HISTORIC PRESERVATION COMMISSION

SUBJECT: Historic Area Work Permit #1154772 – Partial demolition, construction of additions, site work and associated grading

The Montgomery County Historic Preservation Commission (HPC) has reviewed the attached applications for a Historic Area Work Permit (HAWP). This application was **approved with four (4) conditions** at the September 9, 2026 HPC meeting:

PORCH COLUMN
8" ENDURA-ALUMINUM WELLINGTON STYLE COLUMN. SQUARE SHAFT (POST WRAP) PRIMED FINISH PAINTED WHITE W/CAPITAL & BASE

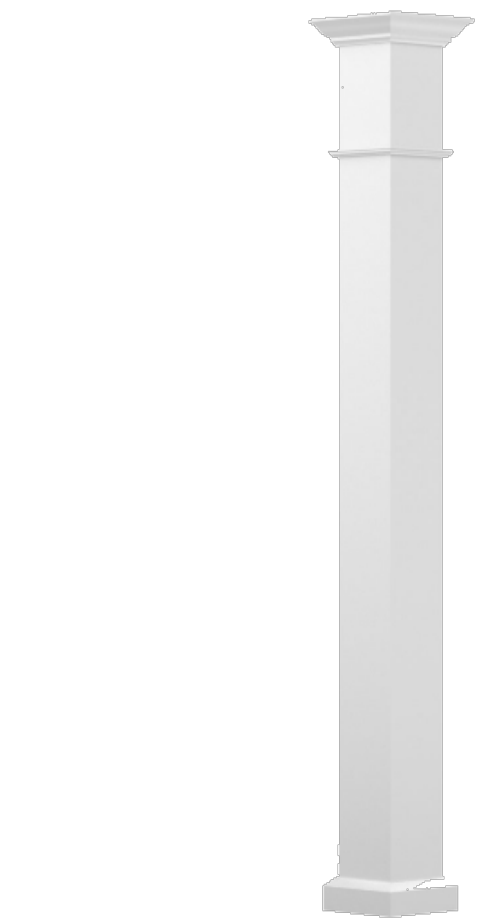
1. The proposed Hardie lap siding must have a smooth finish and a 5-to-7-inch reveal.
2. The applicant must provide either a specification or detailed drawing for the front porch columns, which must have a painted finish.
3. The applicant must provide window specifications and detail drawings showing the proposed window and trim profiles. The windows may be wood, aluminum-clad, or a composite material, and must have traditional sash and muntin profiles consistent with those of historic wood windows.
4. The applicant must update the plans and elevations to show the use of wood or painted composite material for the front porch stairs. The risers and visible stringers must have a smooth, painted finish. The front porch steps may not be metal.
